Access Compliance Report

Public Rights-of-Way

(Curb Ramps)

Intersection ID: 5508	Main Street: THOMAS_COMBS_DR	Cross Street: UNIVERSITY_CITY_BV	Location:	N
ADA ID: 2590D5888289	Ramp Type: Perp	Initial Pass/Fail: Fail	Overall Compliance: No	Severity Score: 41.25
Codes/Mitigation Info/Possible Solution		Field Measurements/Component Compliance

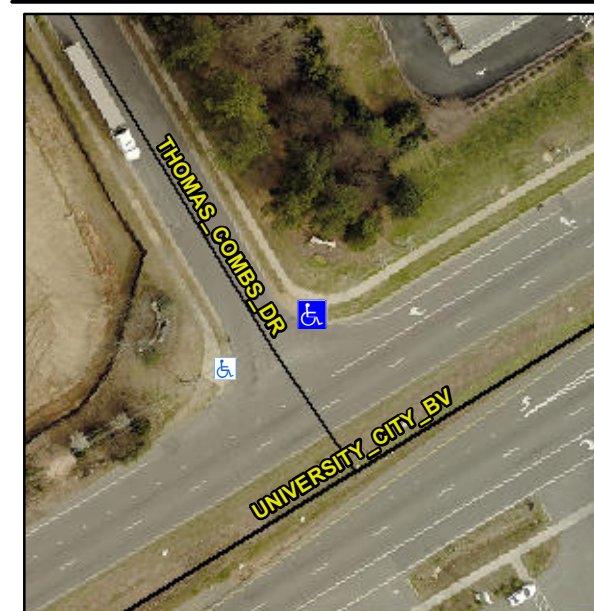
Not Found, R304.2.2, R304.5.3, R302.7

Compliance	Description	Data	Compliance	Description	Data
N/A	Ramp Length (in)	97.0	No	Ramp Slope (%)	20.0
Yes	Ramp Width (in)	48.0	No	Ramp XSlope (%)	2.1
N/A	Flare Type LT	N/A	N/A	Flare Type RT	N/A
N/A	Flare Slope LT (%)	N/A	N/A	Flare Slope RT (%)	N/A
N/A	Flare Traversable LT?	N/A	N/A	Flare Traversable RT?	N/A
N/A	Landing Length (in)	N/A	N/A	DWS Provided?	N/A
N/A	Landing Width (in)	N/A	N/A	DWS Contrast?	N/A
N/A	Landing Slope (%)	N/A	N/A	DWS Length (in)	N/A
N/A	Landing X Slope (%)	N/A	N/A	DWS Full Width?	N/A
N/A	Landing Curb? (Y/N)	N/A	N/A	DWS Offset (in)	N/A
N/A	Shared Landing?	N/A			
N/A	Gutter Ponding?	N/A	N/A	Gutter Slope (%)	N/A
N/A	Gutter Lip Ht (in)	3.0	N/A	Gutter X Slope (%)	N/A
N/A	Painted X Walk1?	No	N/A	Painted X Walk2?	N/A
	X Walk 1 Direction	To SW		X Walk 2 Direction	N/A
N/A	X Walk 1 Width (in)	N/A	N/A	X Walk 2 Width (in)	N/A
	X Walk 1 Slope (%)	2.0		X Walk 2 Slope (%)	N/A
	X Walk 1 X Slope (%)	0.7		X Walk 2 X Slope (%)	N/A

N/A	Ramp inside XWalk1?	N/A	N/A	Ramp inside XWalk2?	N/A
	Road Slope (%)	N/A	N/A	Clear Space?	N/A
	Road X Slope (%)	N/A	N/A	Clear Space to XWalk (in)	N/A
N/A	Any Obstructions?	N/A	N/A	Storm Grate/Utility Hazard?	N/A
	Obstruction Type			Storm Grate/Utility Type	
		N/A			N/A
		No		Surface Condition? (G/P)	Poor

Remove & Replace Entire Ramp.
